ADDENDUM NO.: 3

DATE OF ADDENDUM: July 10, 2014

# CTARNG FACILITY VISION 2020 PROGRAM PROJECT NO. 7 HARTFORD ARMORY ROOF AND SKYLIGHT RESTORATION 360 BROAD STREET HARTFORD, CT BI – Q – 659

FLETCHERTHOMPSON	HARTFORD ARMORY ROOF & SKYLIGHT RESTORATION		DATE 5/13/14
ARCHITECTURE I ENGINEERING I INTERIOR DESIGN	DRAWNGTTHE ROOF VENT AT MAIN SKYLIGHT BASE		PROJECTNO: CT 12137
THREE CORPORATE DRIVE SHELTION, CONNECTIOUT 06484-6244	DRAWNBY: R. MAZZADRA	SCALE 1 1/2"= 1'-0"	DWG.NO: SK-A301

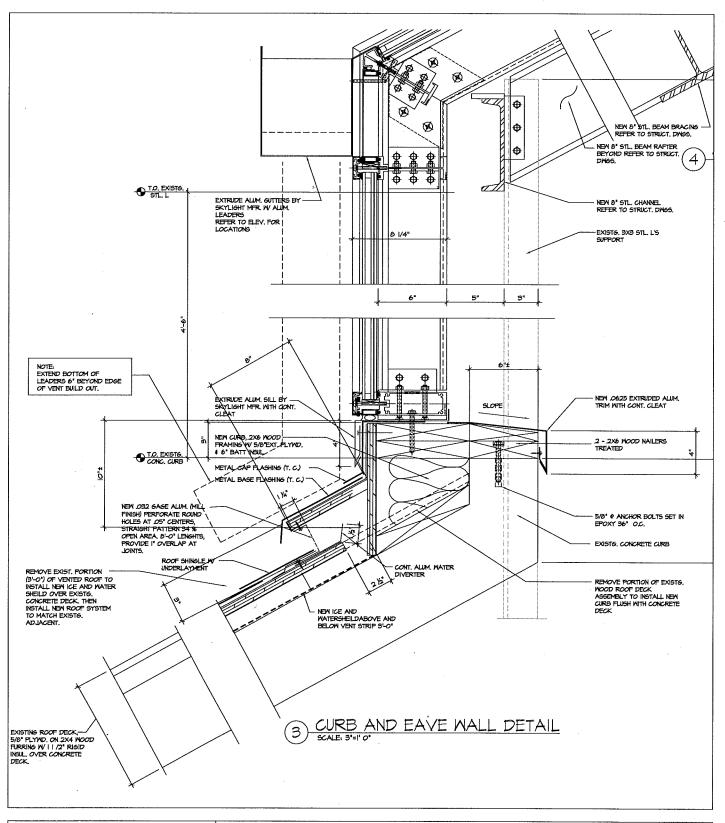
CHANGES TO THE DRAWINGS: On Drawing A301, Detail #3 - Revise the Curb and Eave Wall Detail to include roof venting as indicated on the attached sketch SK-A301.
